Re: **SCI-823-6.81, Portsmouth Bypass Project, PID 19415**  
**Addendum to Report: Shumway Hollow Road (TR 234) Interchange**  
Embankment Stability, Time-Rate of Consolidation, Soil Cut Slope Stability  
DLZ Job No.: 0121-3070.03, Document No. 107

DLZ has reviewed ODOT-Office of Geotechnical Engineering's (OGE's) Stage I review comments (dated January 31, 2007) for Phase 1 of the SCI-823 project. In compliance with the review comments, DLZ has modified the slope stability analyses and time-rate of consolidation calculations for the Shumway Hollow Road (TR 234) interchange embankments. This document also elaborates on our previous recommendations for soil cut slopes and includes the output of the associated stability analyses.

### TIME-RATE OF CONSOLIDATION CALCULATIONS

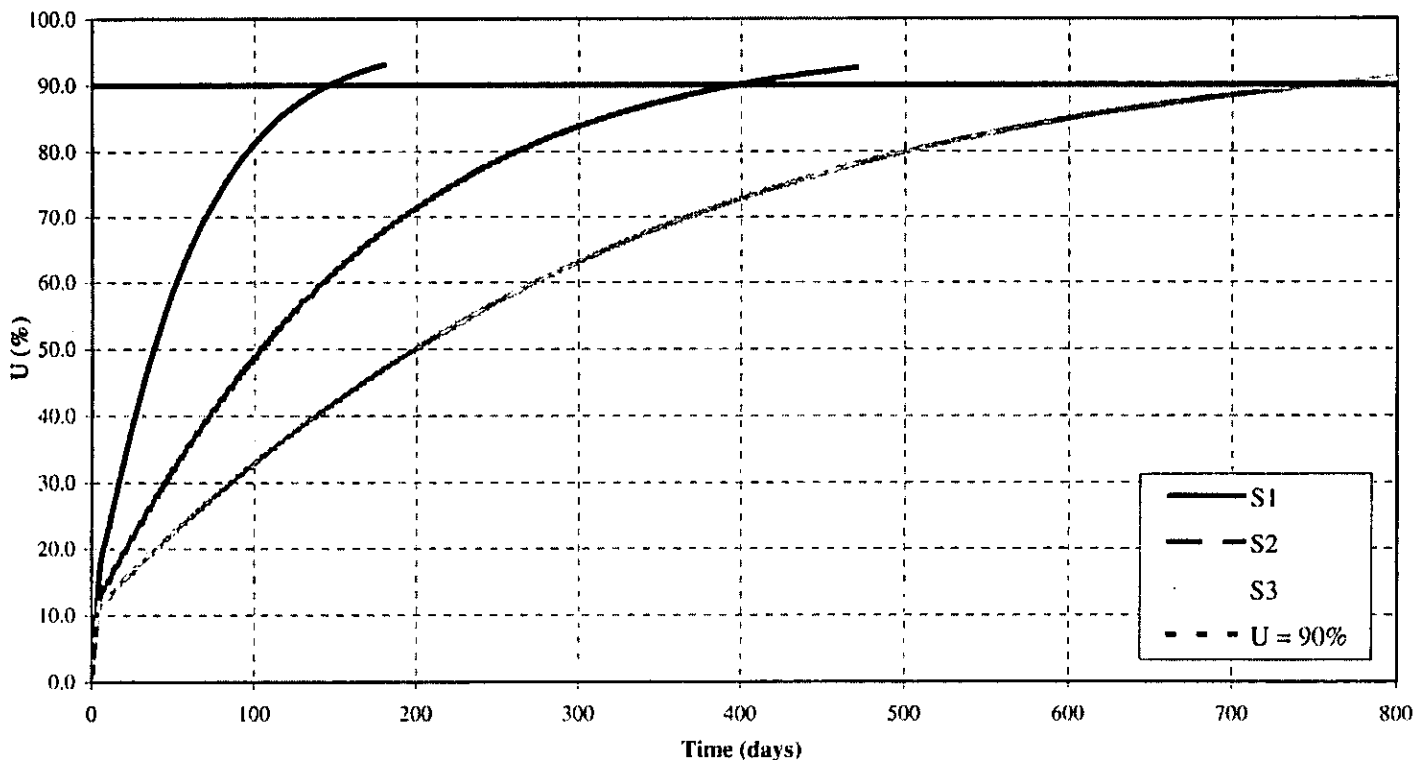
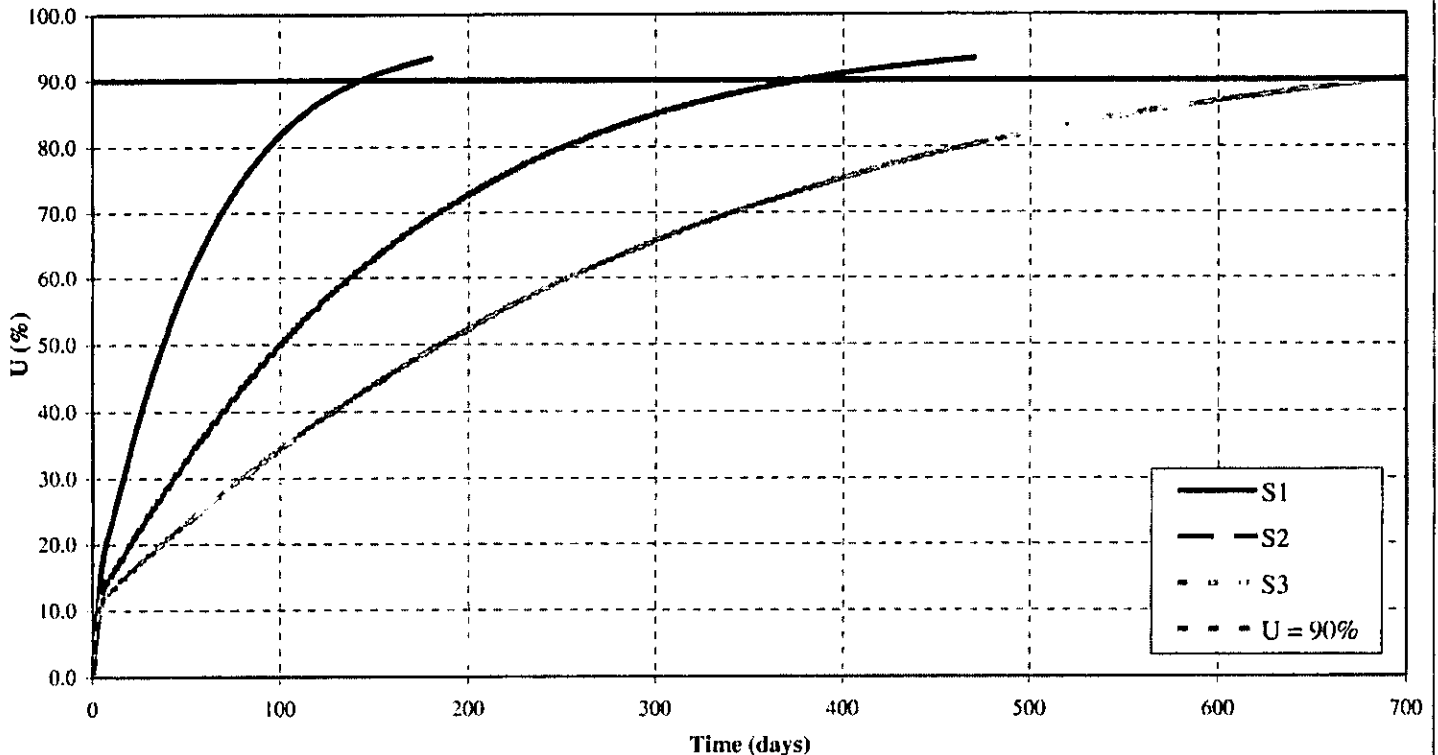
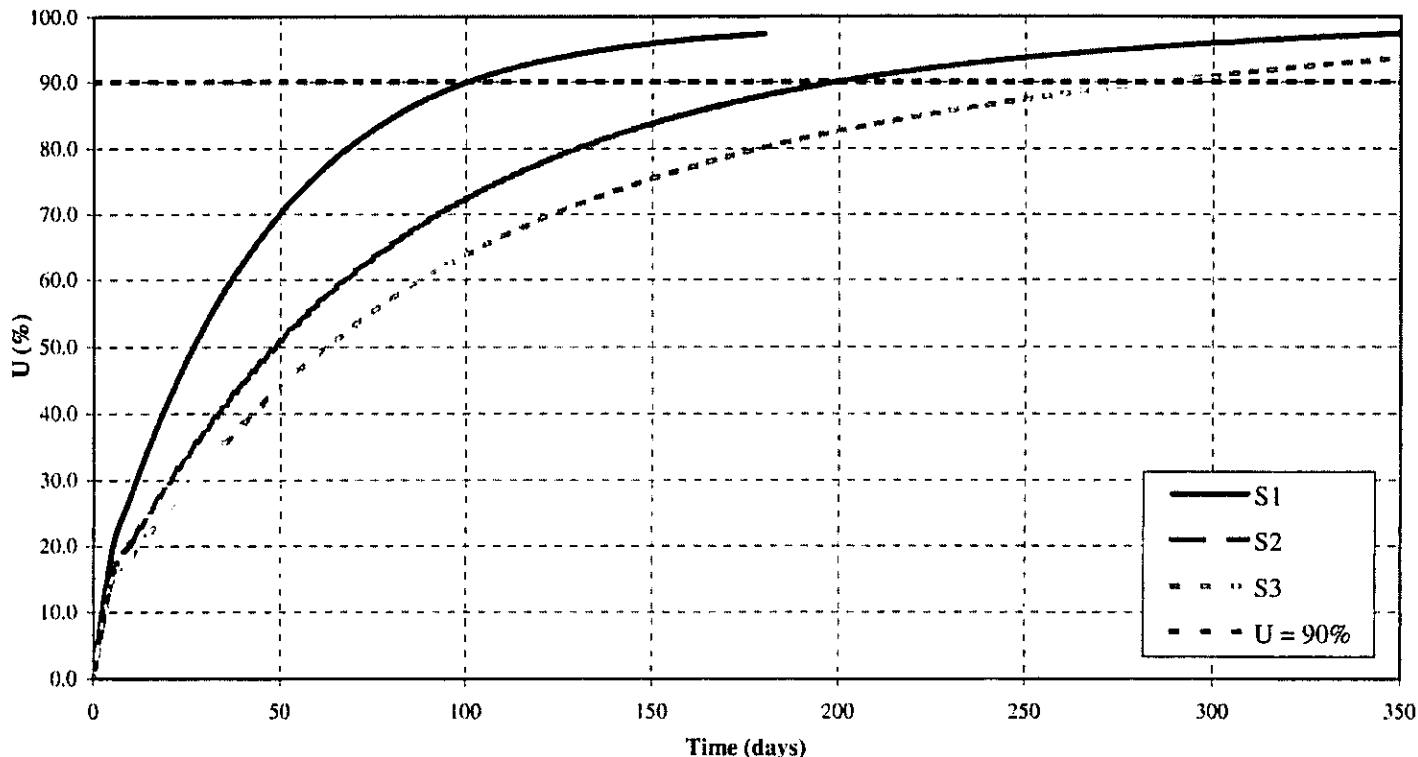
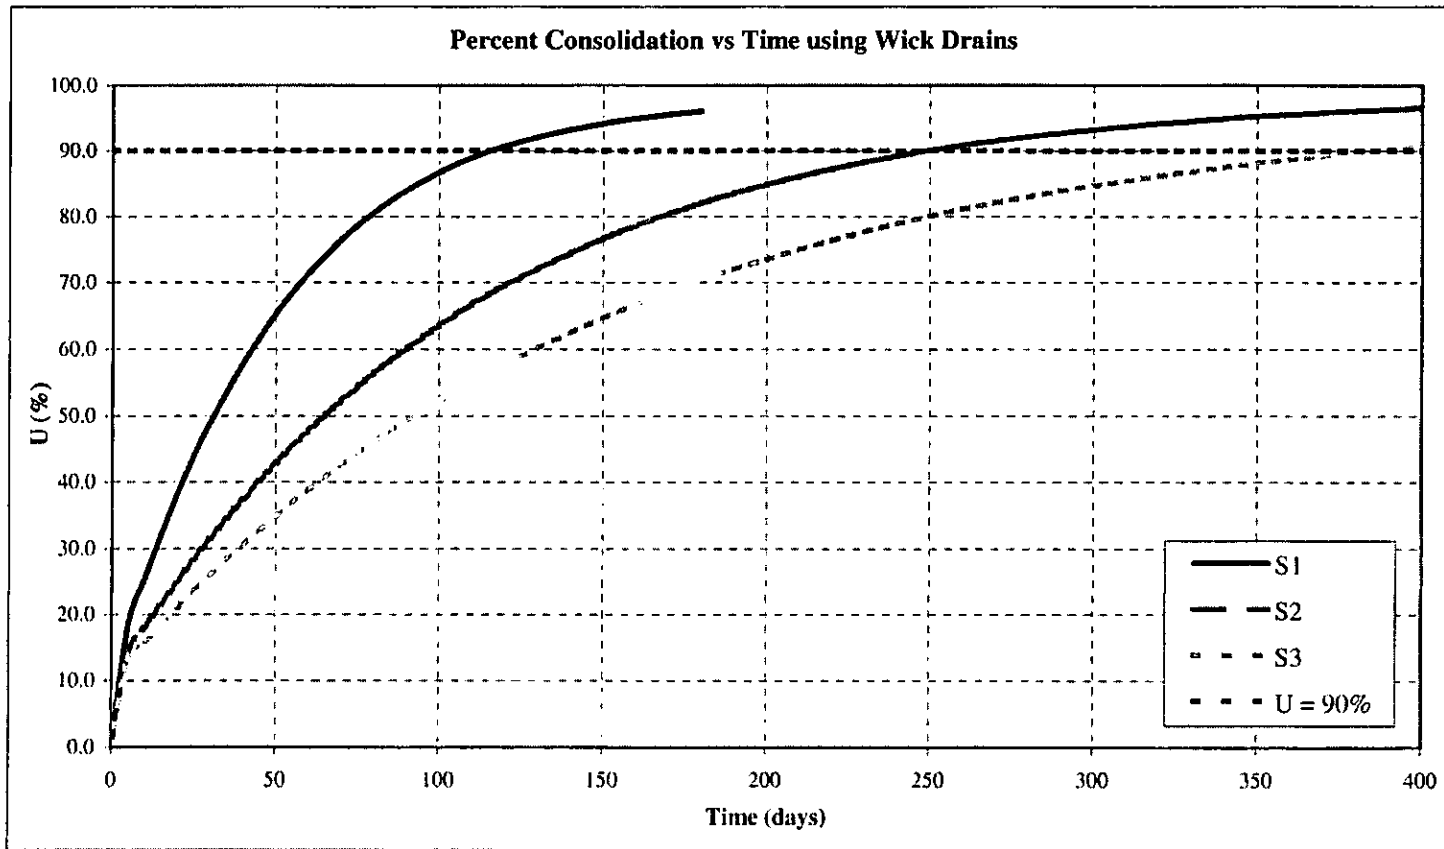
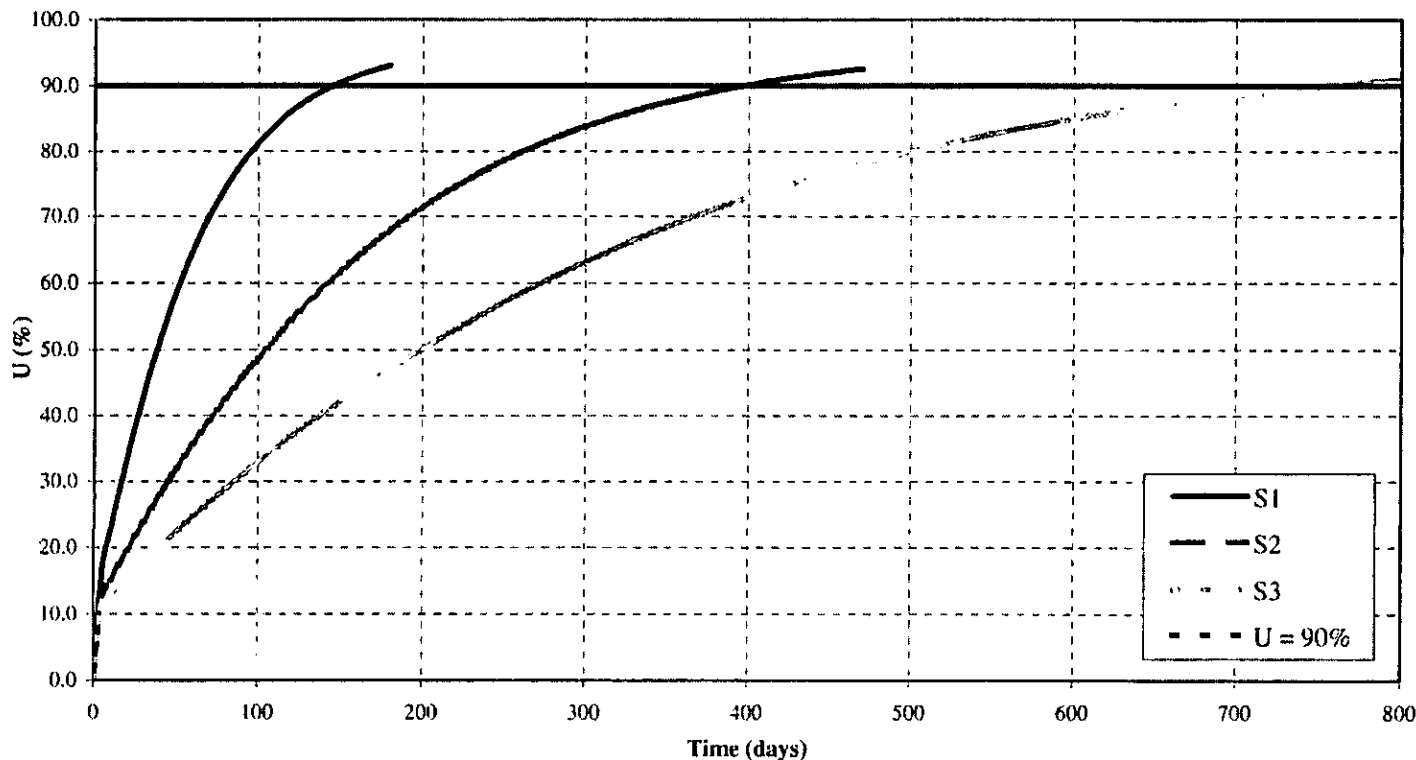
- OGE requested that DLZ use a standard degree of consolidation of ninety percent when citing consolidation times instead of eighty percent.
- OGE suggested that when estimated settlements are in excess of 24 inches, pavement preparation should not commence until at least ninety percent of primary consolidation has occurred.

The time-rate of consolidation calculations were modified based upon the “benchmark” time-rate of consolidation of ninety percent instead of eighty percent. Various wick drain spacing options and the associated consolidation times are also presented. The results of the calculations are presented in the following paragraphs.

As mentioned above, after constructing the stage 1 embankment, ninety percent of consolidation (U=90%) should be achieved prior to placing the subsequent stage. The estimated consolidation times are presented in the following table. It should be noted that these consolidation times are estimates only. The ODOT construction representative should determine when the specified degree of consolidation has occurred based upon settlement and piezometer measurements in the field.
